Resource consent application – Further information request

Application number(s):	BUN60419132 (LUC60419133, SUB60419134)
Applicant:	HND HMB Limited
Address:	3 Pigeon Mountain Road, Half Moon Bay
Proposed activity(s):	92 dwellings, including earthworks, access, parking and subdivision

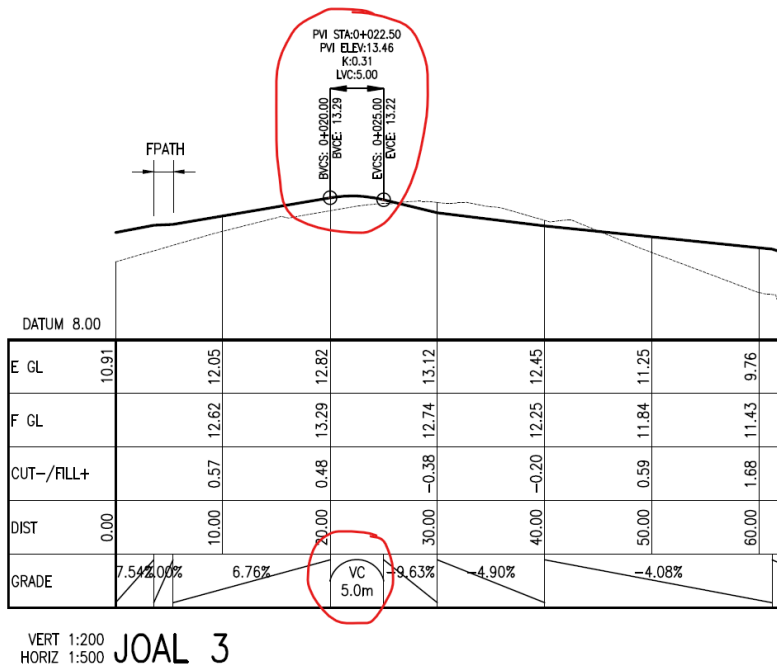
46. Please confirm the width of all driveways in front of Units 1 to 22.
47. Units 24 to 41 are provided with garages with doors that have a width of approximately 5.0 m, into a room with an internal width of 5.3 m. While the plans now show these garages as only serving a single vehicle, they remain of a design that would physically allow for two vehicles to be parked.

If these garages are used for two parking spaces, the second space would conflict with the bin storage areas for Units 25, 28, 31, 34 to 36, 39 and 42. Therefore, please either:

- a. Identify alternative suitable bin storage areas should the future residents choose to park a second vehicle in these garages and provide assessment of the suitability of providing a width that enables a second vehicle while being below the minimum width expectation of 5.5 m for a double garage; or

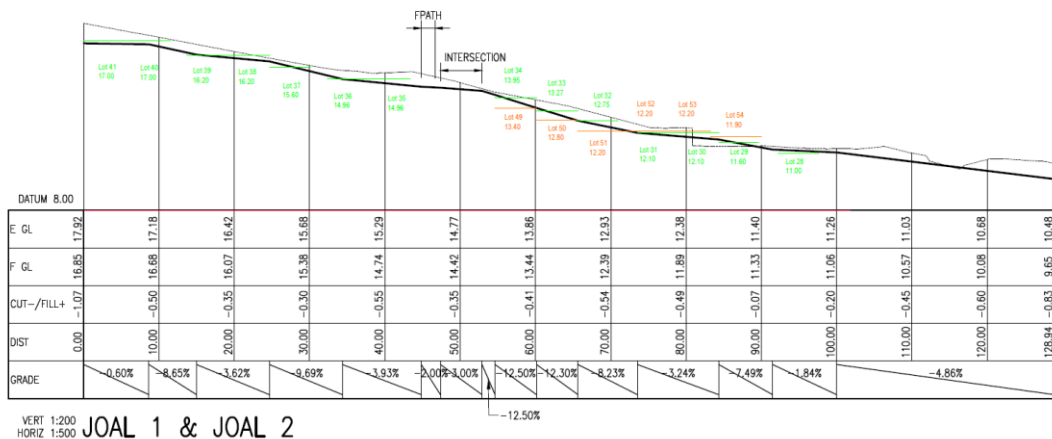
60. Significant clarification is requested in order to demonstrate that the proposed gradients of JOALs 1 and 2 and the parking spaces for Units 34 to 60 comply with Standards E27.6.3.6(3) (maximum 5% in any direction for parking spaces), E27.6.3.6(4) (maximum 12.5% for manoeuvring areas) and E27.6.4.4(1) (maximum 12.5% for vehicle access used by heavy vehicles, measured on the inside radius).

While the provided longitudinal section for JOALs 1 and 2 shows a maximum gradient of 12.5%, there is doubt in regard to practicality of tying into adjacent garages and parking spaces while not exceeding this gradient in any direction. This doubt results from the following observations, amongst others:

- a. The finished levels for the adjacent lots being up to 0.7 m different from the levels of the adjacent accessway, as shown on the provided longitudinal section for JOALs 1 and 2. It is further noted that the levels shown for Lots 23 to 41 are the flat levels of the proposed garages, and the levels for Lots 33 and 34 are over 0.5 m higher than level of the adjacent accessway.

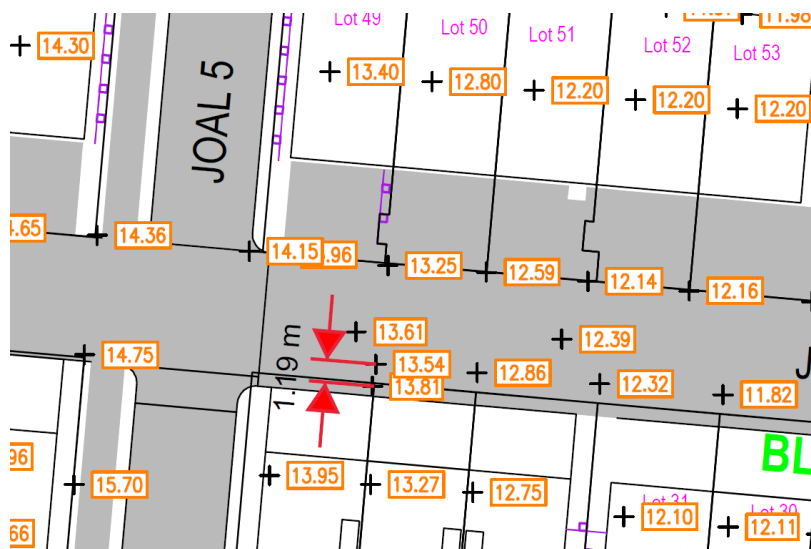
- b. The 3D imagery provided within the architectural plans seemingly shows JOAL 2 is not flush with the garages of Units 23 to 41, including 'covering over' part of the garage doors.

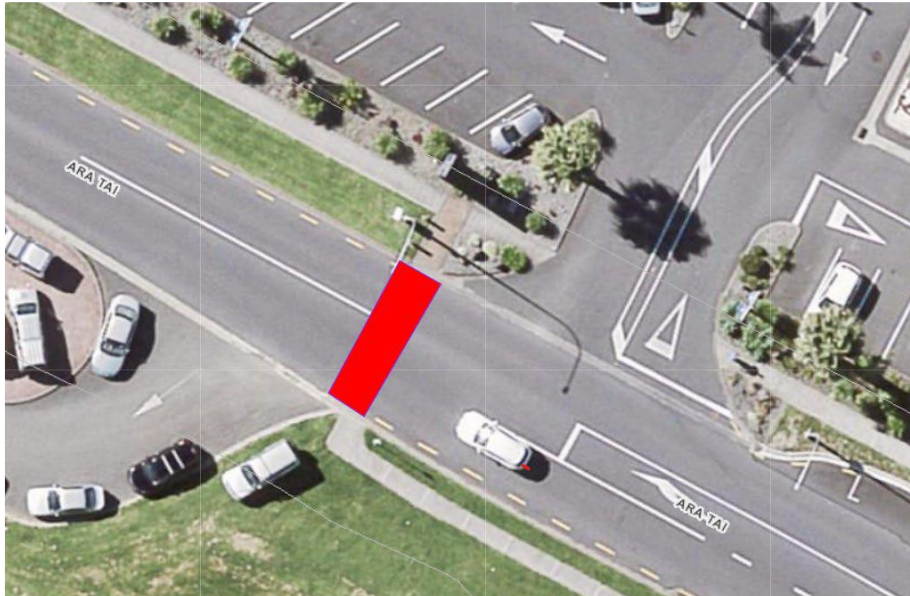
63. Please provide signage and markings plan (directional arrows within the boundary to route traffic flows) including analysis of how cross-roads (private) and 90-degree bends will function within JOALs. This information is required to ensure operations and safety of internal driveway traffic is maintained.
64. Please confirm if there will be any sightlines issue (visibility envelope) given 90-degree bends around the proposed driveway. Please provide assessment and accordingly provide mitigations to ensure safe ingress/egress of vehicles at all times.

Auckland Council recommends use of convex mirror to mitigate safety effect.

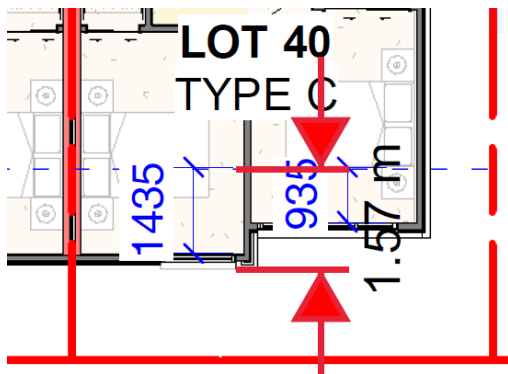
- b. Sheet 203 specifies the height of the proposed retaining wall being the difference between proposed finished ground levels and the bottom of the existing retaining wall (i.e. a stepped retaining wall);
- c. Drawing L112 does not specify any fencing on top of the proposed retaining wall, but shows a 1.8 m fence at the existing boundary (top of the existing retaining wall);
- d. Drawing RA1401 appears to show that a fence will be constructed above the proposed retaining wall to a height up to the top of the existing retaining wall (refer below);

- e. During the site visit, the applicant indicated that the area between the existing retaining wall and the proposed retaining wall (and fence indicated on Drawing RA1401) would be backfilled; and
- f. Sheet 200 does not show any earthworks between the existing and proposed retaining walls.

In particular, please confirm:

- g. The height at the top of the proposed retaining wall (is this consistently the same as the bottom of the existing retaining wall?).
 - h. The height of any fencing above the proposed retaining wall (noting that a fence above this wall will likely be required by the Building Code where the fence is more than 1 m in height).
 - i. Whether any fill earthworks are proposed between the existing and proposed retaining walls (and its fence).
3. Based on the response to RFI item 2, please provide further commentary regarding the extent to which Units 81 to 92 are provided with access to daylight and sunlight as required by Policy H4.3(5)(b).

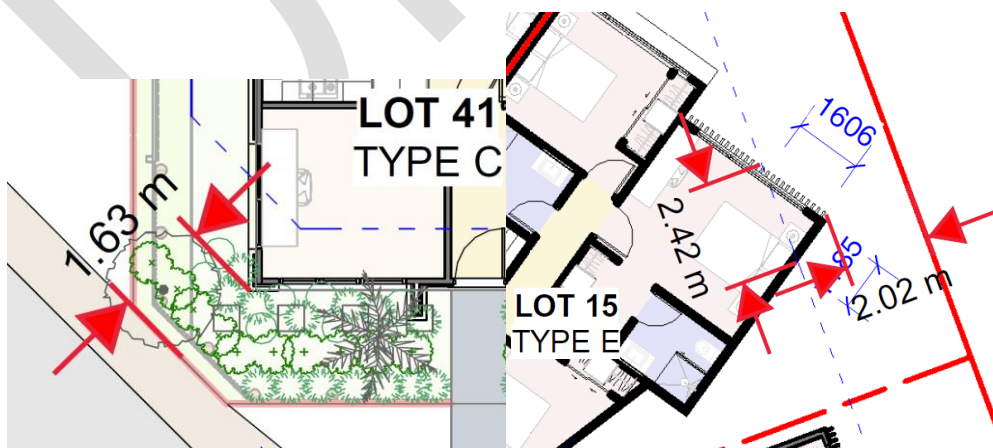
11. Please clarify the proposed set back of Blocks E and F from Compass Point Way. Drawing RA0100 shows a yard intrusion of 1.049 m, associated with the ground/mid level, Drawing RA0151 shows a yard intrusion of 0.857 m for Block E and 0.980 m for Block F, associated with the ground/mid level, Drawing RA0152 shows a yard intrusions of 1.435 m and 0.935 for both Blocks E and F, associated with the upper level, while Drawings RA1306 and RA1307 do not show any upper level overhangs on the side elevations. It also appears that the provided dimensions for the yard intrusions are to the internal wall rather than the exterior face of the wall (refer below), which leads to misleading and inaccurate assessment of the proposal. If the front yard intrusion of Blocks E and F is greater than that identified in the AEE, please update the assessment. If the intrusion is over 1.5 m, as indicated below, then please acknowledge that this setback would also be infringing the MDRS standard, indicating that this outcome is inconsistent with the neighbourhood's planned urban built character.

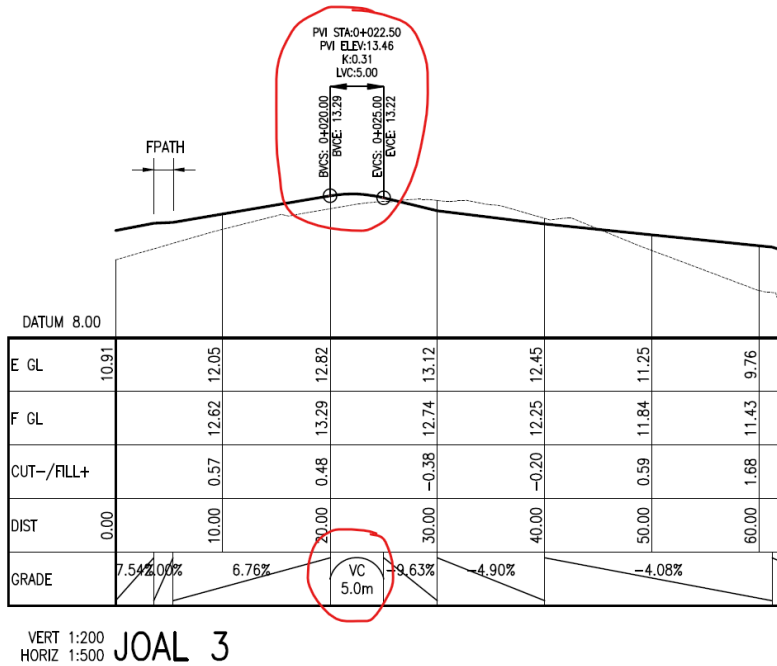
For Units 24, 27, 30, 33 to 35, 38 and 41, it is proposed to store rubbish bins within and against the side of these garages. The proposed 240 litre recycling bins are assumed to have a depth of 0.73 m, leaving only 4.57 m for two parking spaces.

The AUP requires a minimum width of 4.8 m for two parking spaces, while NZS2890 identified that a minimum 5.4 m internal width should be provided for double garages (with 300 mm clearance on either side).

Please provide additional commentary regarding the appropriateness of the proposed double garage internal widths, including the impacts of requiring bins to be stored in this location.

JOAL 1 & JOAL 2

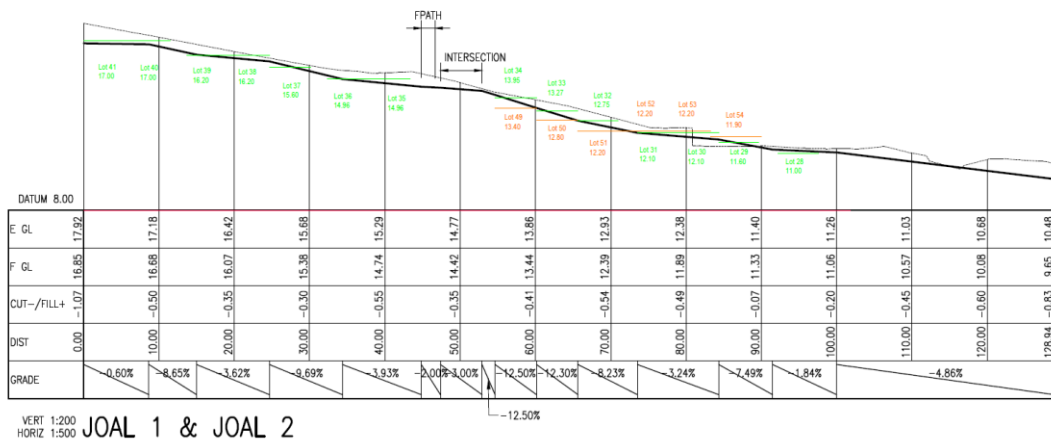
41. Significant clarification is requested in order to demonstrate that the proposed gradients of JOALs 1 and 2 and the parking spaces for Units 42 to 59 comply with Standards E27.6.3.6(3) (maximum 5% in any direction for parking spaces), E27.6.3.6(4) (maximum 12.5% for manoeuvring areas) and E27.6.4.4(1) (maximum 12.5% for vehicle access used by heavy vehicles, measured on the inside radius).

While the provided longitudinal section for JOALs 1 and 2 shows a maximum gradient of 12.5%, there is doubt in regard to practicality of tying into adjacent garages and parking spaces while not exceeding this gradient in any direction. This doubt results from the following observations, amongst others:

- a. The finished levels for the adjacent lots being up to 0.7 m different from the levels of the adjacent accessway, as shown on the provided longitudinal section for JOALs 1 and 2. It is further noted that the levels shown for Lots 23 to 41 are the flat levels of the proposed garages, and the levels for Lots 33 and 34 are over 0.5 m higher than level of the adjacent accessway.

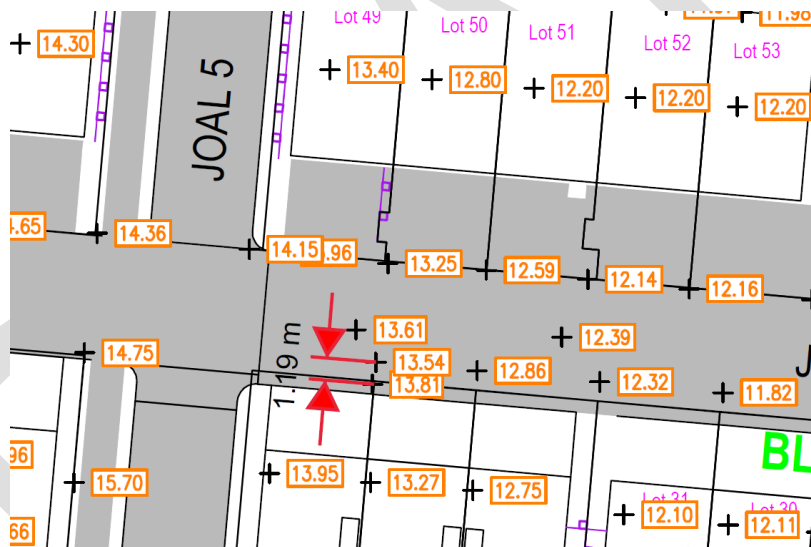
- b. The 3D imagery provided within the architectural plans seemingly shows JOAL 2 is not flush with the garages of Units 23 to 41, including 'covering over' part of the garage doors.

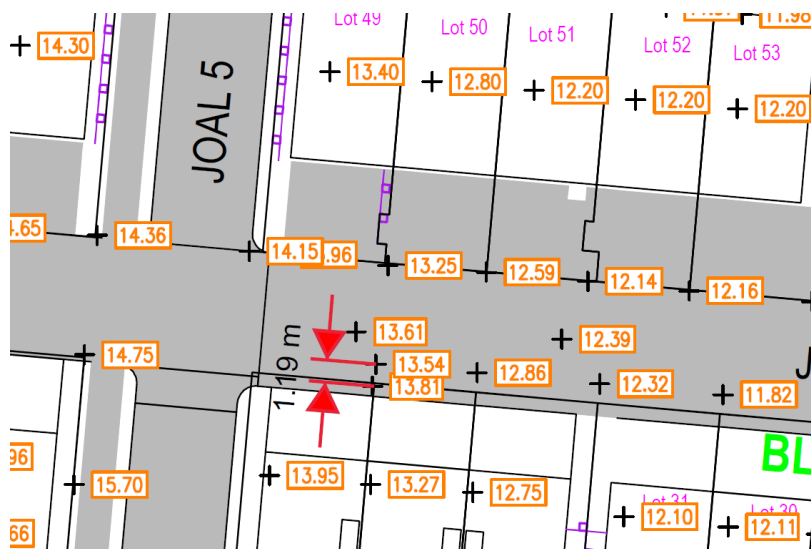
- b. The 3D imagery provided within the architectural plans seemingly shows JOAL 2 is not flush with the garages of Units 23 to 41, including 'covering over' part of the garage doors.

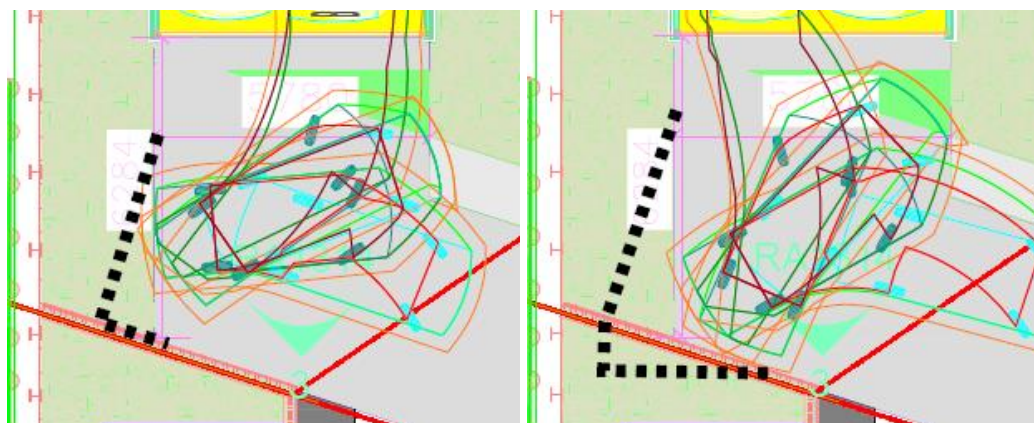
- a. Please provide an assessment of the outdoor living spaces for Units 87 and 88 against the purpose of Standard H4.6.13. In particular, please clarify how the provided depth and area of the provided balconies are of a functional size and dimension for the likely number of occupants.

The requested assessment against the purpose of Standard H4.6.13 has not been provided.

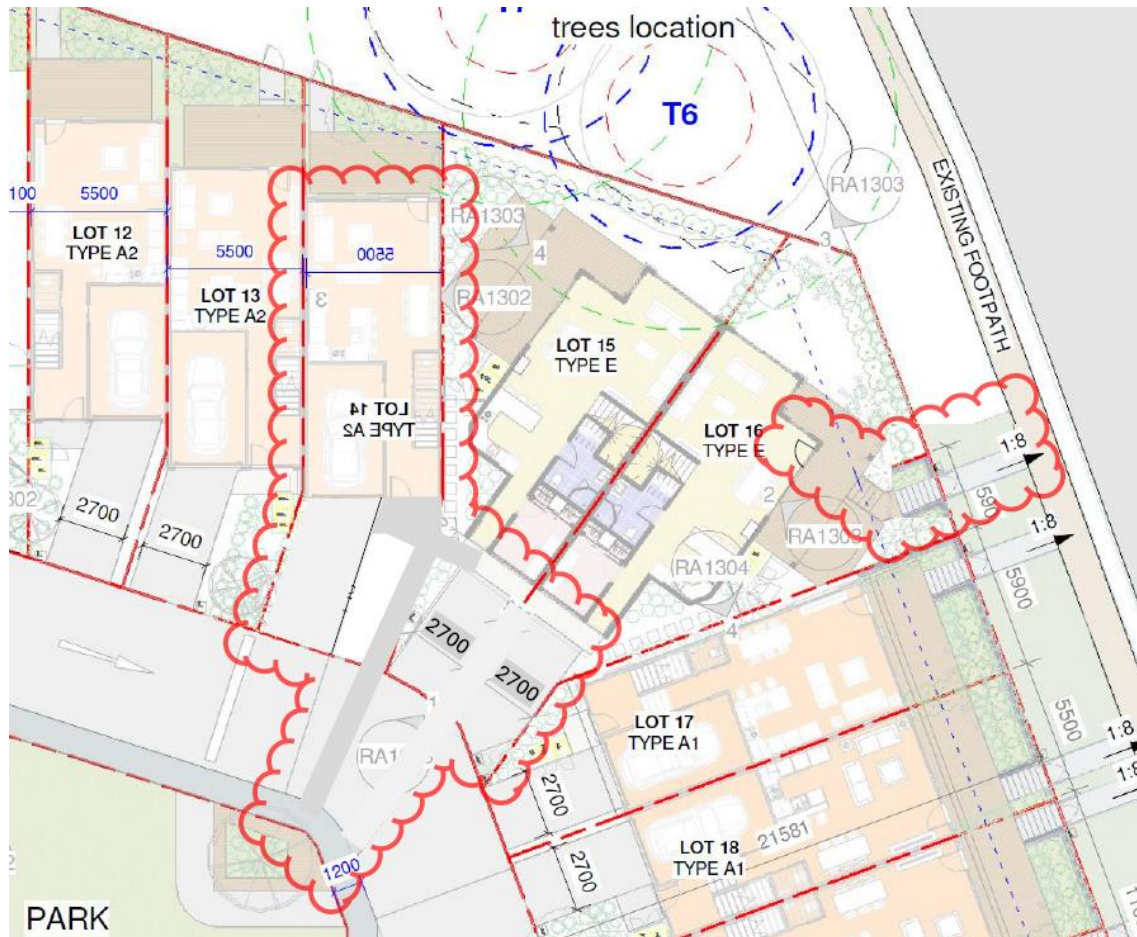
- The fence between decks and adjacent terraces of adjacent units is only a 1.2m high semi-permeable fence where fronting a road or JOAL. While this may be an appropriate design response for a front yard, it does not provide sufficient privacy for this space as a primary outdoor living area. The conflict of these being both has not been resolved adequately.

In addition, Blocks I, J and K provide a 1.6m high semi-permeable fence to separate adjacent private outdoor areas (at the rear of units). It is not clear why a lower fence standard and permeability is required.

In general, where outdoor living spaces are fronting streets / JOALS, a 1.6m semi-permeable fence and/or significant screening from landscape is required between adjacent units as a minimum. Where outdoor living spaces are not fronting these spaces (Block K, I), a min. 1.8m closed fence is recommended. OLS in Blocks F and E are separated by architectural walls.

Please consider updating the landscape plans to address the comments above.

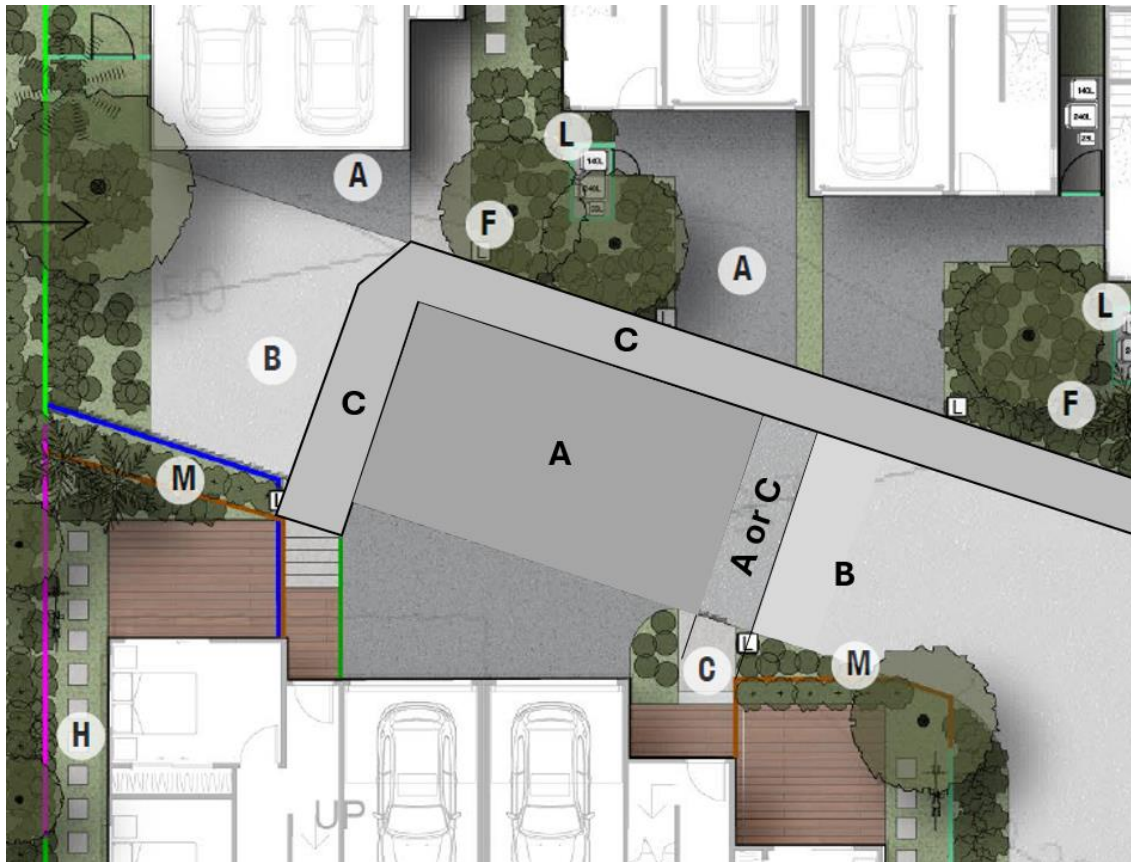
- The revised pedestrian access outcomes for Lots 15 and 16 are considered to be poor, with a path width of only 900 mm provided that is sleeved between two narrow carparks. It is expected this would be frequently parked over, limiting pedestrian access to these units. It is noted a secondary pedestrian access is provided for Unit 16 to Pigeon Mountain Road. Were this to be formed as a primary pedestrian entry, Unit 14 and 15 might be redesigned (mirroring Unit 14) to provide a shared pedestrian path to Unit 14 and 15 (at least 1.2 m in width). Refer to the sketch below. Please consider making these changes to address these concerns.

- It is recommended that a visual crossing point for Unit 87 and 88 be provided to connect to the pedestrian path opposite. This could include adjusting the extent of the already proposed 'banding' of the proposed accessway to align with the entrances to Units 87 and 88. Refer to the sketch below.
